# UNITED STATES PATENT AND TRADEMARK OFFICE

10/618,095

## Office Action Summary

**DETAILED ACTION**

**FIG. 2**

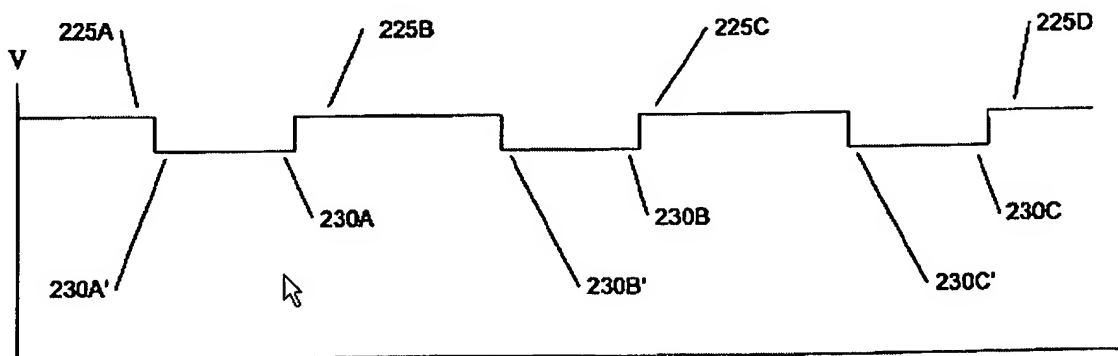
As to claim 1, Podrazhansky discloses in figures 1-4 a method comprising:

drawing a substantially constant first current pulse 210 [see fig.2; column 3, line 35] from an energy storage cell 11 during a first time period 210A between a starting time 220A and an ending time 220B [see fig.2];

the battery voltage is measured to provide voltages during the discharge pulses, and the voltage differences among two or more of these measured voltages are used [see fig.2]

and comparing the measured first change to first stored data/curve or LUT [see column 1, lines 44-51].

means 16 for drawing a substantially constant first current pulse 210 [see fig.2; column 3, line 35] from an energy storage cell 11 during a first time period 210A between a starting time 220A and an ending time 220B [see fig.2];

means for measuring the battery voltage during the discharge pulses, and the voltage differences among two or more of these measured voltages are used [see fig.2]; and

Fig - 1

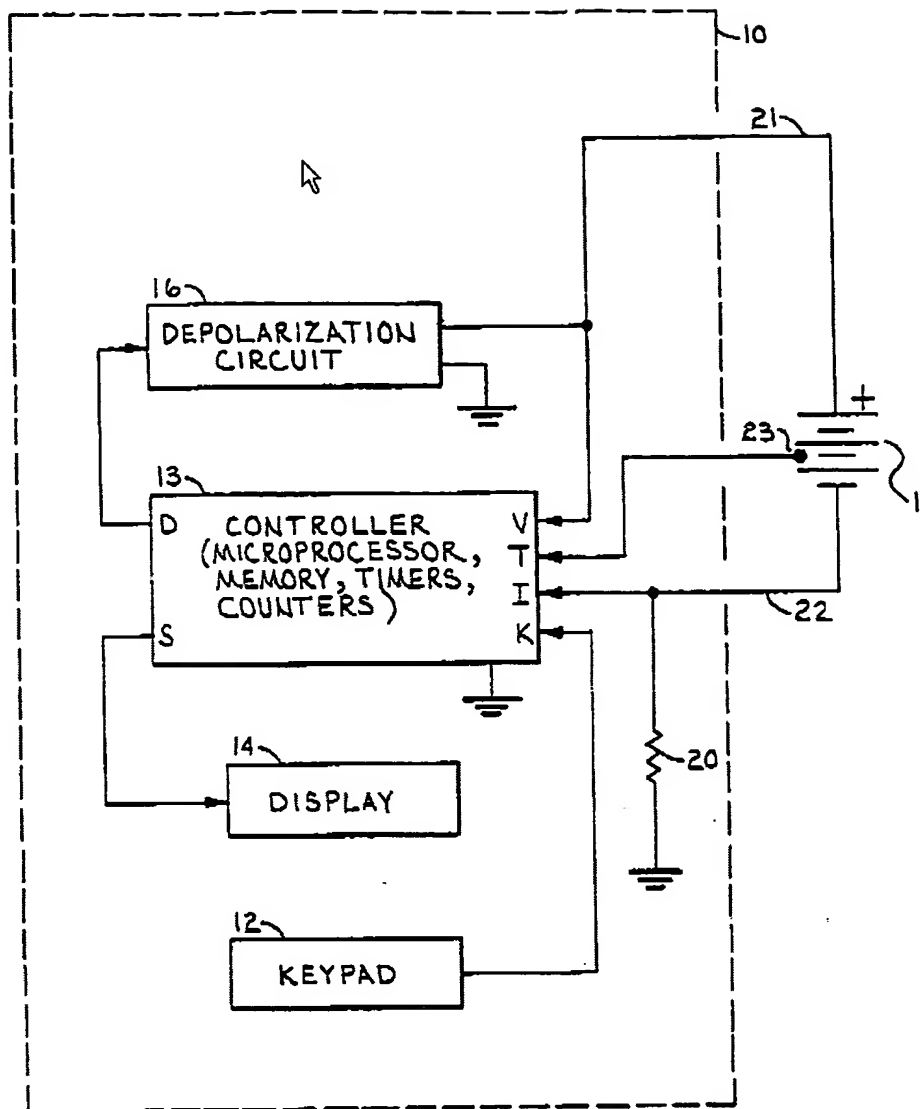
Claim 20: "a processor circuit, **coupled to or including** the difference circuit" is not clear as a) fig.1 shows the difference circuit as part of the processor, and b) the use of "or" makes the claim language confusing because it is not clear what applicant is actually claiming. Furthermore, applicant is reminded that "or" should only be used with alternate terms, e.g., rod or bars, etc. To continue prosecution it was assumed the processor circuit **includes** the difference circuit.

an energy storage cell 11;

a current source/sink circuit 16, coupled to the cell, to draw a substantially constant first current pulse;

a difference circuit 13, coupled to the voltage measurement circuit, to compute a difference between the first and second voltages;

and a processor circuit 13, including the difference circuit, the processor circuit including a memory circuit [see fig.1] to store first data/curve or LUT [see column 1, lines 44-51] relating cell
